## **ADDENDA 3 ISSUED JANUARY 9, 2017**

### **Progress Meeting Minutes**

**Project:** Harmony School of Innovation – Waco – Remodeling

**2** SITE PLAN (FOR REFERENCE)  
1" = 40'-0"

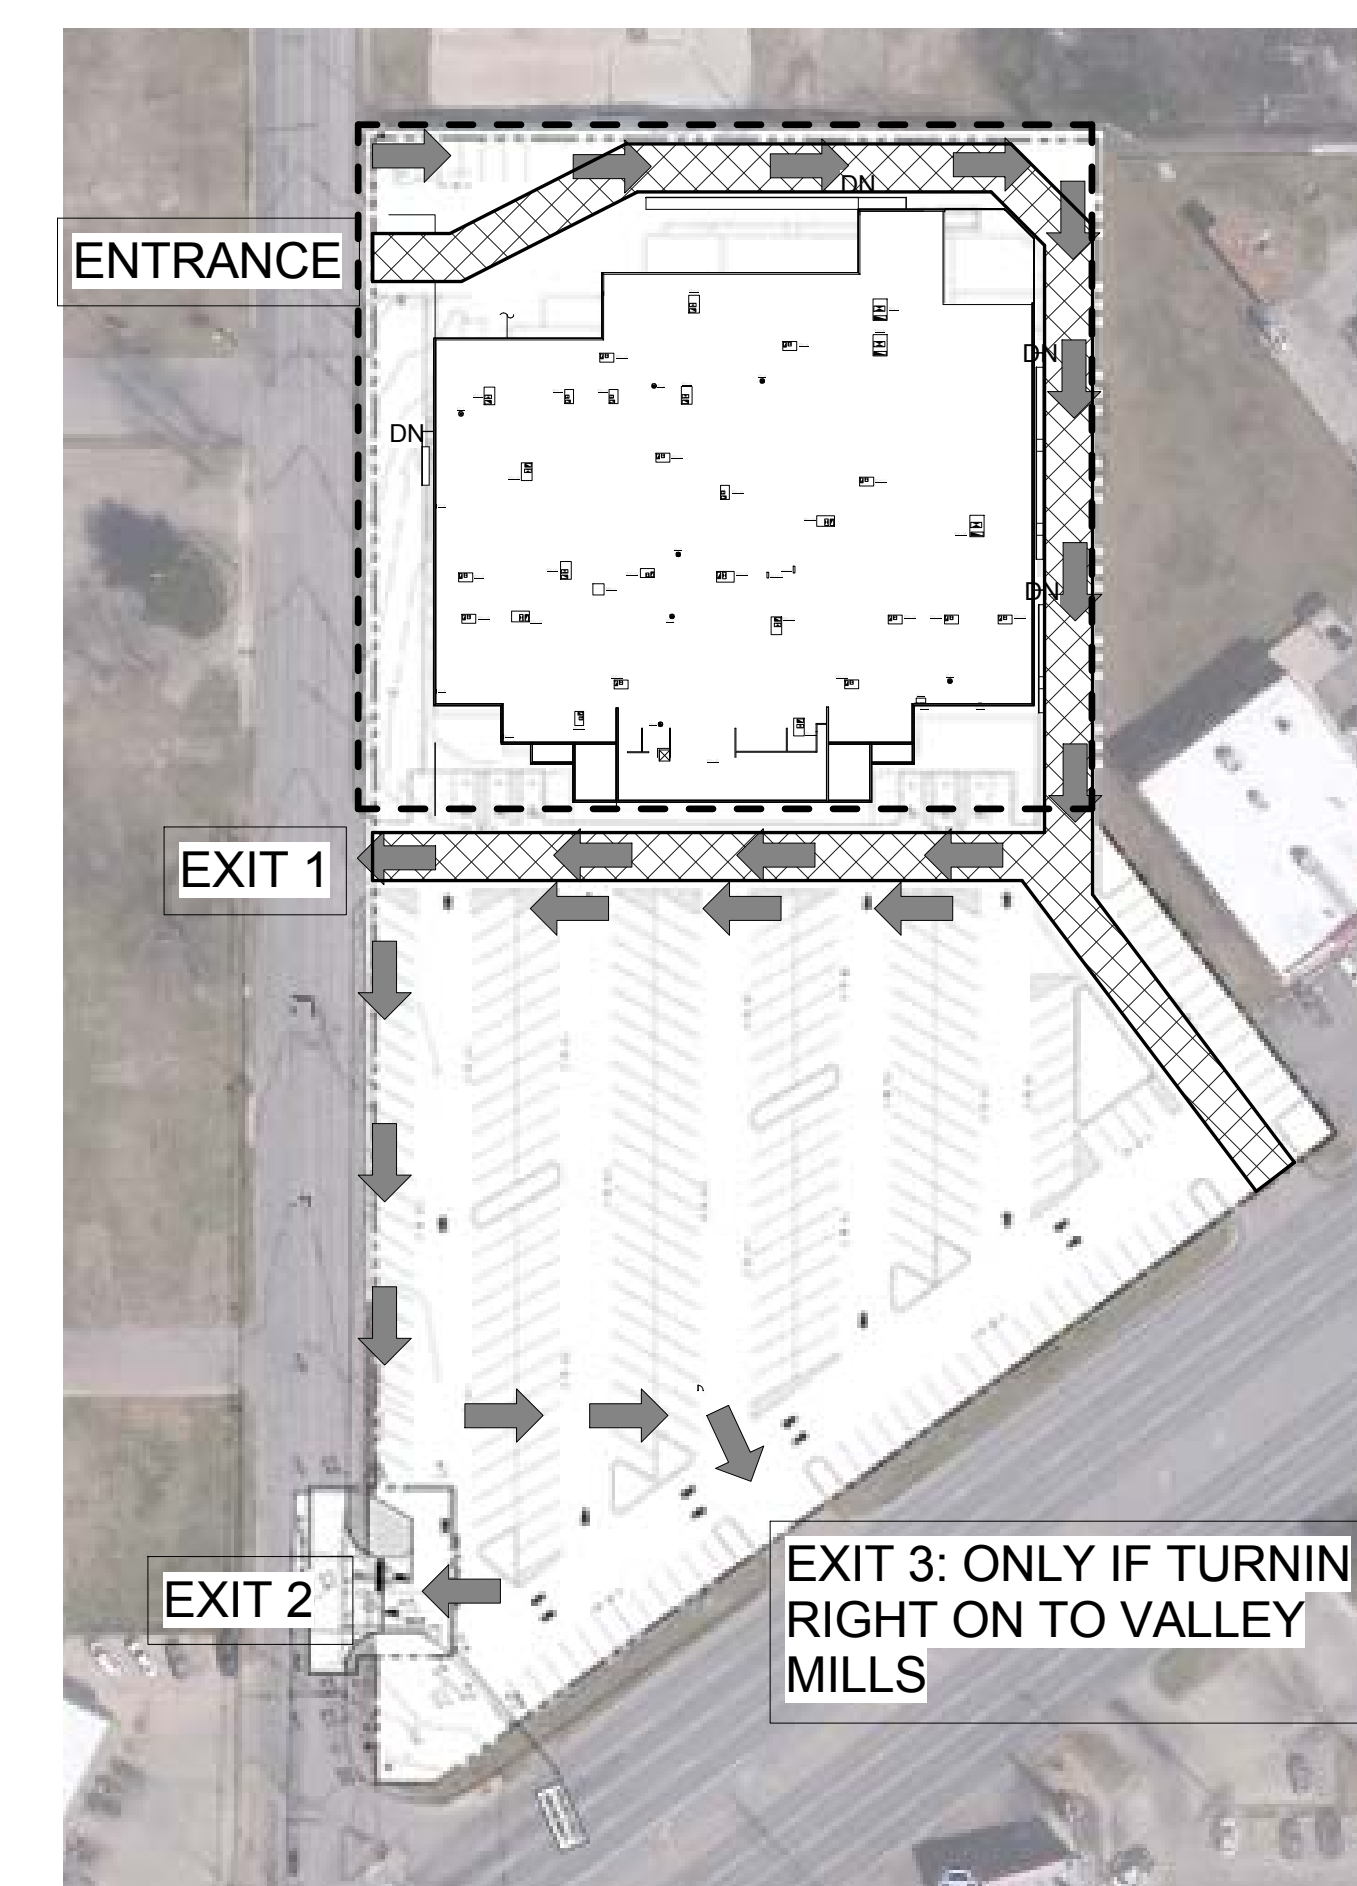
24. The note regarding Fire Alarm in the plan is a bit vague , could you please clarify?  
-GC is to meet minimum code requirements for Fire Alarm
25. Will a fence be installed around the facility?  
-Yes, a standard 6' high Chain-link fence will be installed. The gates will be manually operable. Architect will show location on sheet A0.1 Site Plan.

.....  
LOCATION OF NEW 6 FOOT HIGH GALVANIZED CHAIN LINK FENCE.

# Classroom Specs

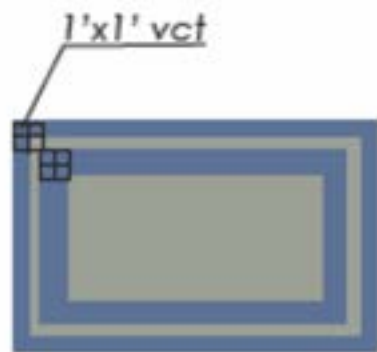
31. The pattern spec is a bit vague, can the architect provide a more clear spec?  
-Yes, the owner will share photos of the pattern for the hallway and classrooms with the architect, which will be share with GCs. See attached photos.

AZROCK  
V-259  
Blazer Blue

AZROCK  
V-280  
Powdered Grey

Pattern

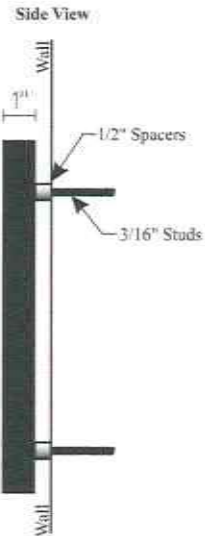
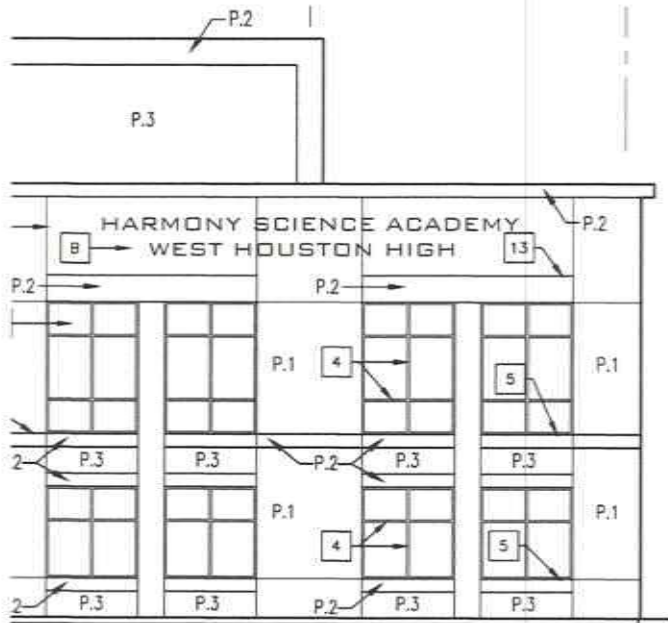
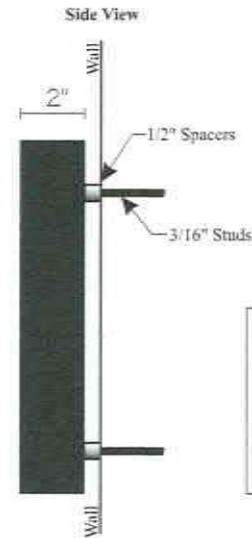
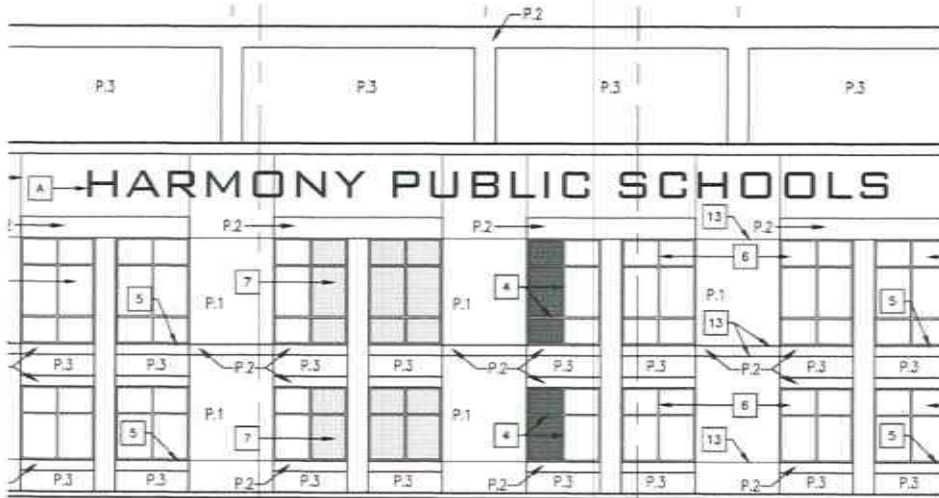
11. Will the architect share a shop drawing for the sign in front of the building?
  - Yes, HPS has shared a shop drawing with the architect and it will be share with the GCs.

Aluminum fabricated reverse channel Bank Gothic Lt. Bt. letters with 1" returns.  
Painted black with Mathews Polyurethane paint.  
Blind stud mounted with silicone adhesive 1/2" from wall using stud spacers .

**Specifications**  
Aluminum fabricated reverse channel Bank Gothic Lt. Bt. letters with 2" returns.  
Painted black with Mathews Polyurethane paint.  
Blind stud mounted with silicone adhesive 1/2" from wall using stud spacers .
